Williams Aviation Consultants

Williams Aviation Consultants, Inc (Williams) has been retained by Development Partners to review the proposed Troutdale Energy Center project located north of the Portland-Troutdale Airport (TTD) in Troutdale, OR. The purpose of the review was to analyze and determine the validity of objections raised by the Oregon Pilots Association (OPA) which claims the project will significantly impact aeronautical operations and flight safety.

**Response to issues and concerns raised by the Oregon Pilots Association in their Petition for Discretionary Review, dated April 3, 2012 concerning Case No. 2012-ANM-538-OE, 2012-ANM-542-OE, 2012-ANM-546-OE, 2012-ANM-547-OE
“Combined Cycle Exhaust Stacks, Simple Cycle Exhaust Stacks, Troutdale, OR”
Issued March 19, 2012**

Exhibit 1 – TTD VFR Traffic Pattern

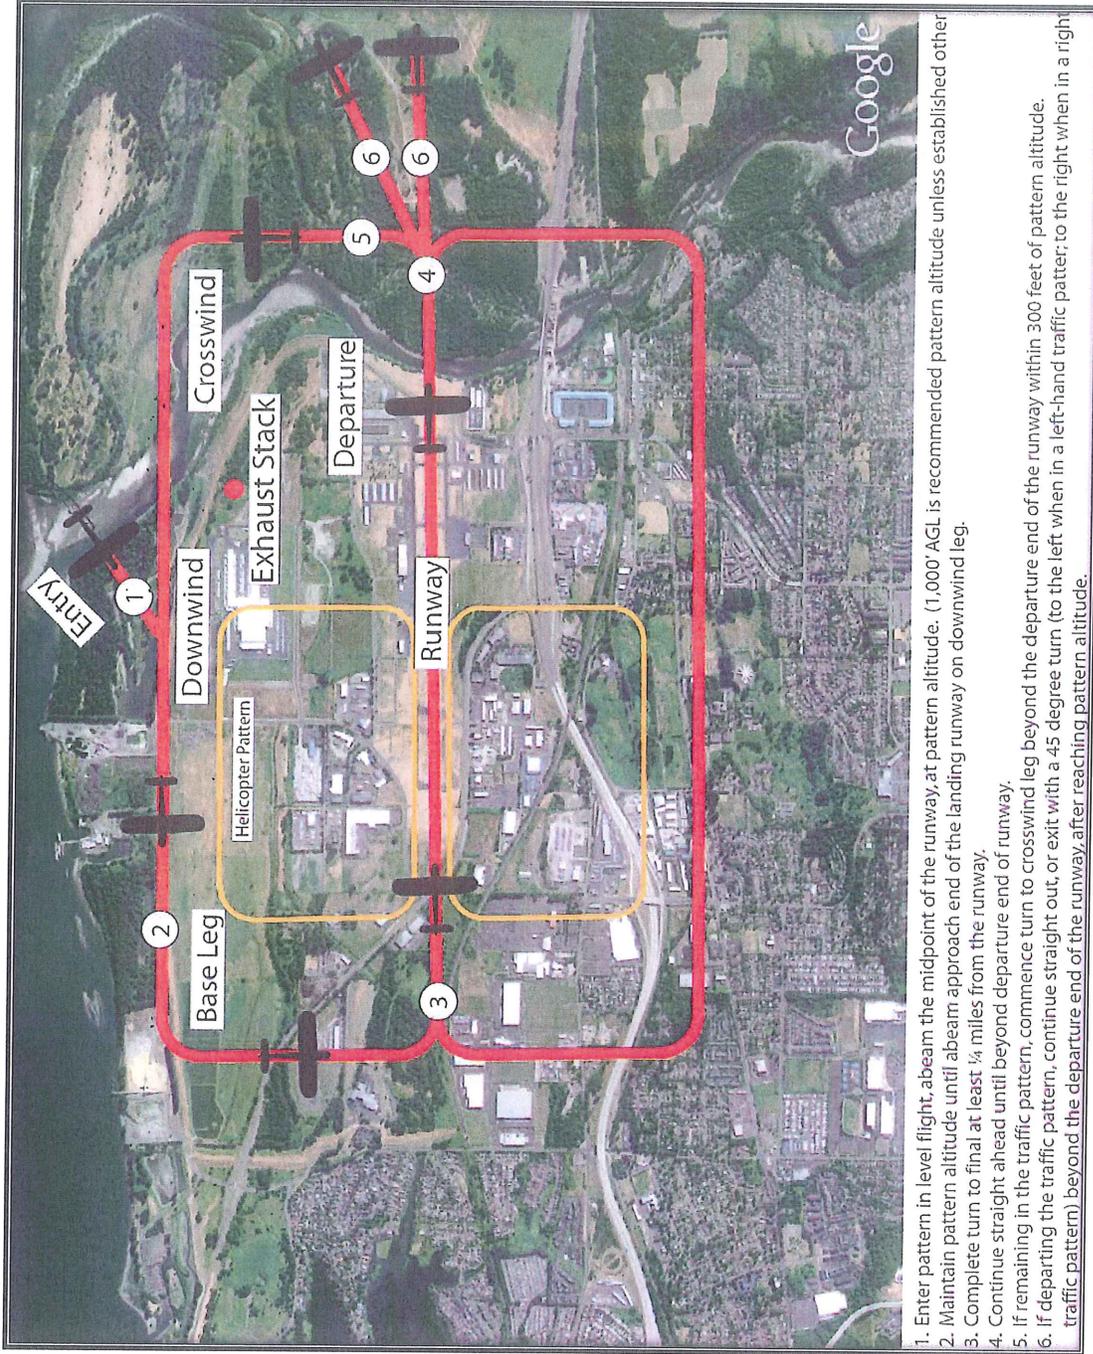
Troutdale Energy Center location in regard to the “45” Entry to Runway 7/25

Pilots operating in compliance with the FAA recommended practice for traffic pattern entry will enter the downwind leg of the Runway 7/25 traffic pattern at a 45 degree angle abeam the midpoint of the runway. The ground track of these aircraft does not pass over the Troutdale Energy Center location, and it would not be necessary for a pilot to overfly the facility.

Exhibit 3 – Area of Over Flight - Blue Lake Three Departure

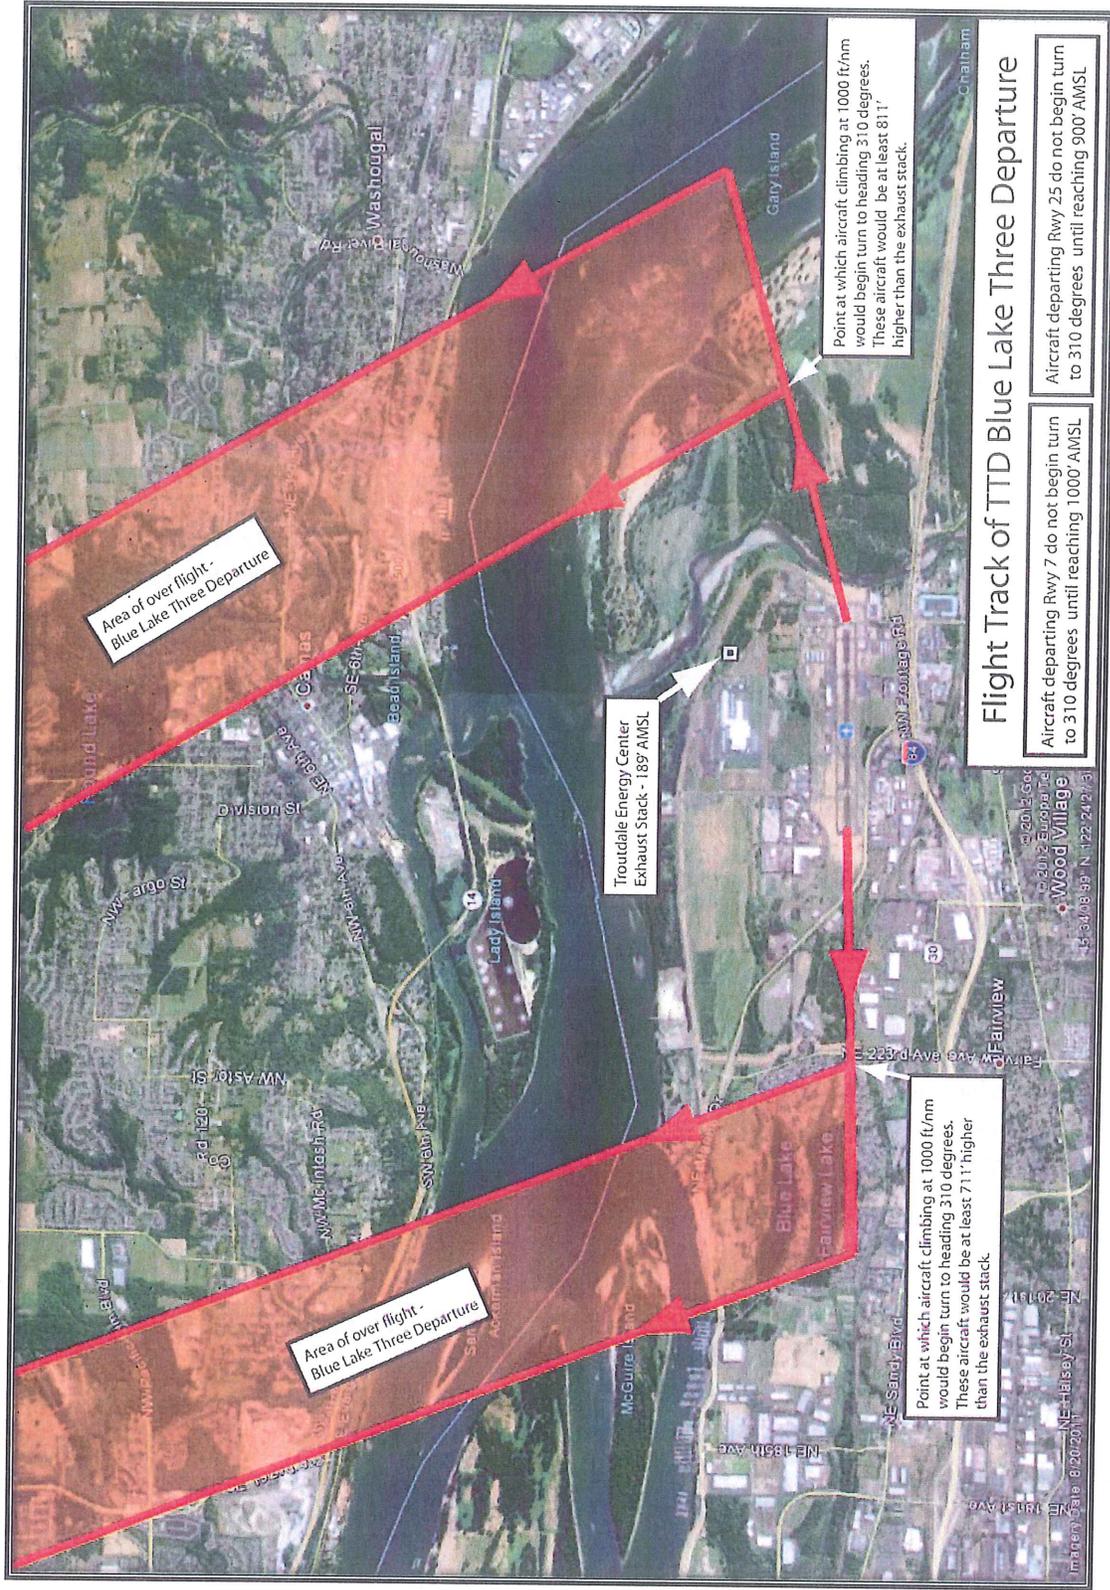
OPA Objection – The energy project will require an alteration to, or the complete elimination of the existing Blue Lake Three Instrument Departure Procedure

Williams Conclusion: as confirmed by the FAA's and Williams' aeronautical study, the energy project will have no impact on the Blue Lake Three Instrument Departure. Additionally, this specific IFR procedure requires aircraft to reach 1000' Above Mean Sea Level ("AMSL") before turning north. This altitude restriction ensures aircraft are never in proximity to the exhaust stack or its plume.

Figure 1 - Elevation to which a structure can be erected without exceeding the TTD FAR Part 77 Obstruction Surfaces

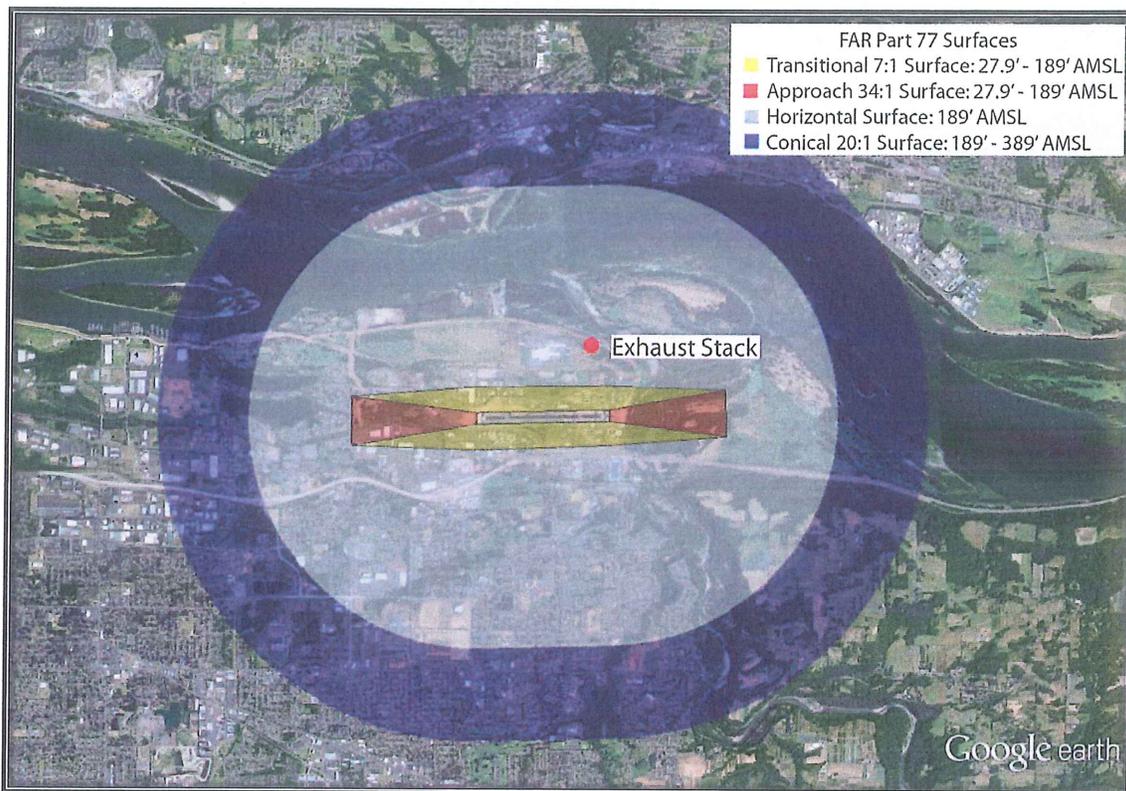
The proposed Troutdale Energy Center Exhaust Stacks will be located within the boundaries of the horizontal surface as defined in FAR Part 77.19(a). The horizontal surface extends outward from the transitional surface and has a constant elevation of 150 ft above the airport (189 ft AMSL). *Figure 1* displays the exhaust stack in relation to the FAR Part 77 obstruction surfaces.

Conclusion: The proposed 189 ft AMSL exhaust stack will not exceed the horizontal surface.

Figure 2 - Elevation to which a structure can be erected without exceeding the TTD VFR Traffic Pattern Criteria

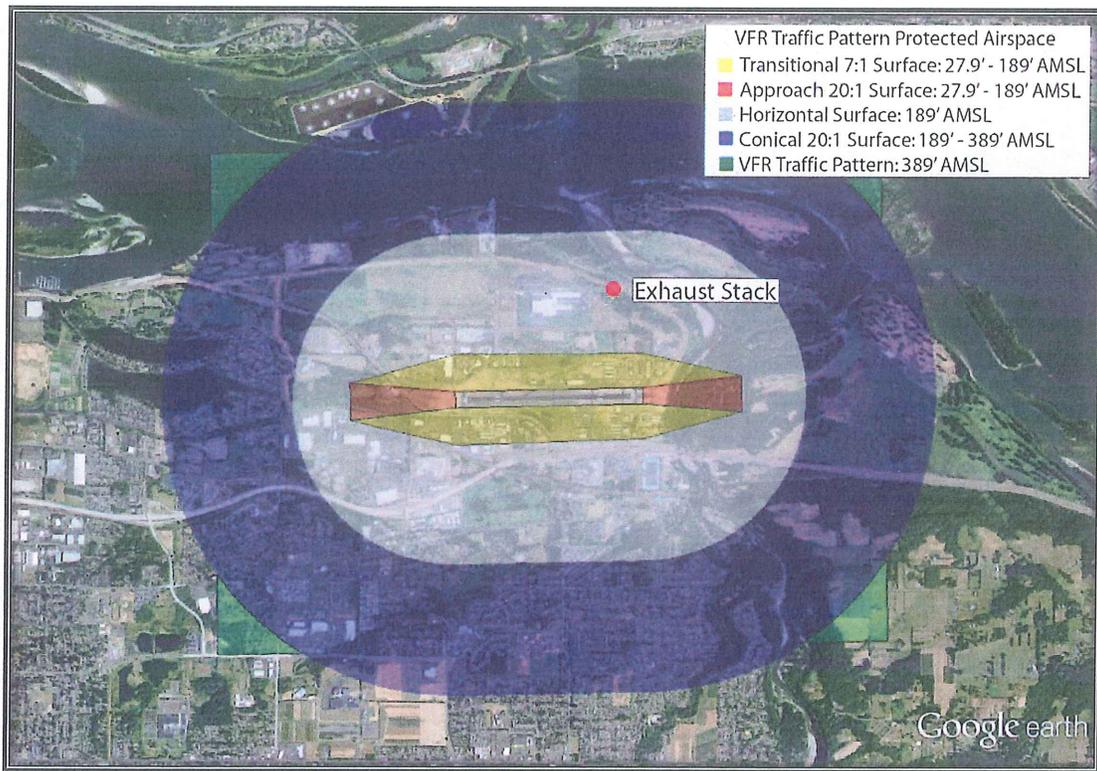
The proposed Troutdale Energy Center exhaust stack will be located within the boundaries of the TTD Horizontal Surface as applied to visual runways. *Figure 2* displays exhaust stack in relation to the surfaces that define the VFR Traffic Pattern.

Conclusion: The proposed exhaust stack will not exceed the TTD Horizontal Surface (as applied to VFR runways) and therefore will have no impact on the aircraft operating in the VFR Traffic Pattern.

Figure 4 – Boundary of Initial Climb Area associated with TTD Instrument Departure Procedure

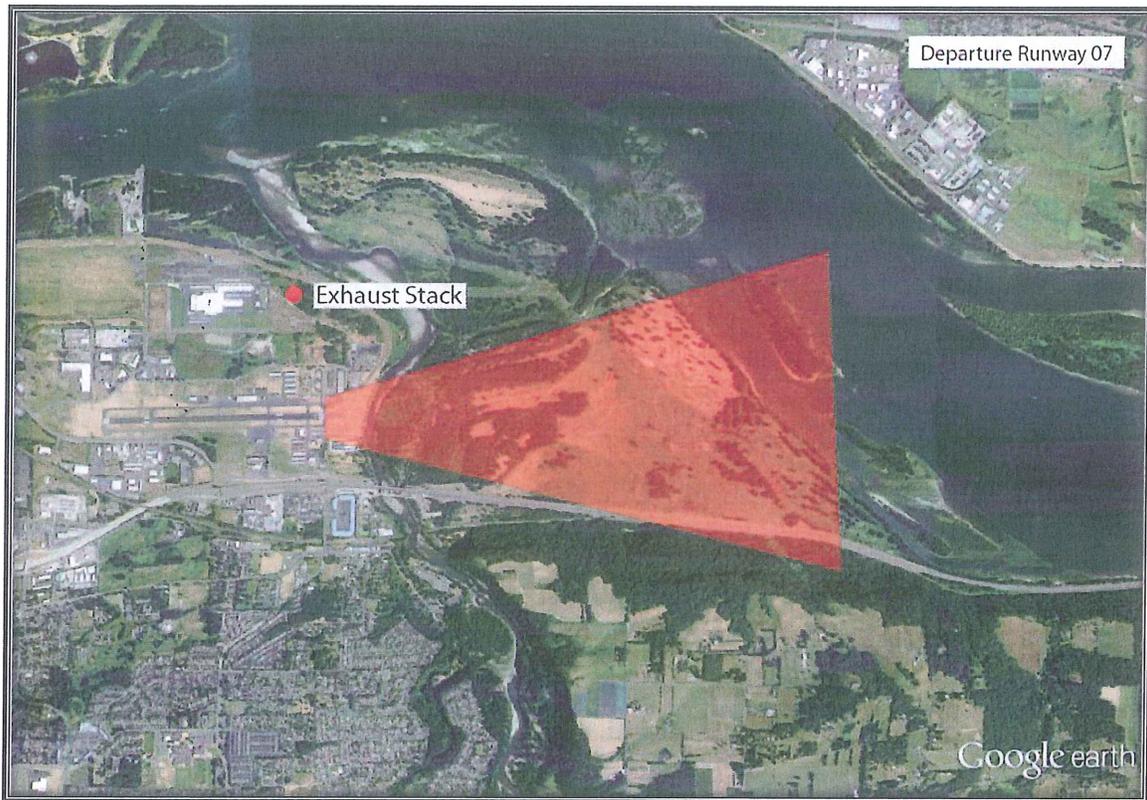
An analysis of the TTD Instrument Departure Procedures was completed to determine if aircraft departing during instrument conditions would be impacted. *Figure 4* displays the proposed exhaust stack in relation to the obstacle clearance surfaces that protect the TTD Instrument Departure Procedure.

Conclusion: The proposed exhaust stack will not be located within the boundaries of the obstacle clearance surfaces associated with the TTD Instrument Departure Procedure and therefore will have no impact on the TTD Instrument Departure Procedures.
